Case No. 15VARIANCE1087

4319 Barbour Lane

**Louisville Metro Board of Zoning Adjustment
Public Hearing**

**Joel P. Dock, Planner I
February 15, 2016**

Proposed Easement Location

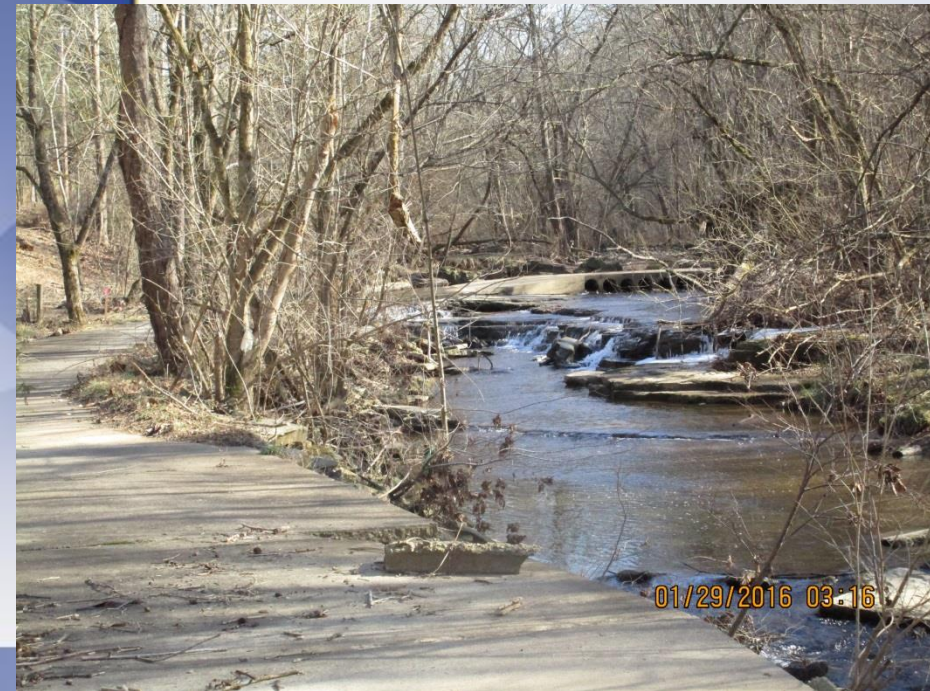
- **Variance** from section 4.8 and Table 4.8.1 of the Land Development Code (LDC) to allow the construction of a private access easement in the Protected Waterway Buffer of Little Goose Creek.
- The Southern line of the pavement encroaching into the buffer appears to be 35'-42'. The easement width extends 6' North & South of the Pavement.

- The applicant proposes to construct a 30' private access easement with a finished pavement width of 18' in the 100' Protected Waterway Buffer of Little Goose Creek to serve five proposed single-family tracts.
- Little Goose Creek is a Perennial or Solid Blue-Line stream.
- Chapter 4, Section 8.6 prohibits structures or impervious surface in excess of 100 SF to be located in the buffer of a protected waterway
- Section 8.6.J of this chapter allows for roads, bridges, trails, and utilities to cross protected waterways if the crossing is the minimum necessary for installation, access, and maintenance; any disturbance required for installation is restored; the number of crossings is the minimum to provide adequate access; and the crossing is perpendicular to the stream or buffer.
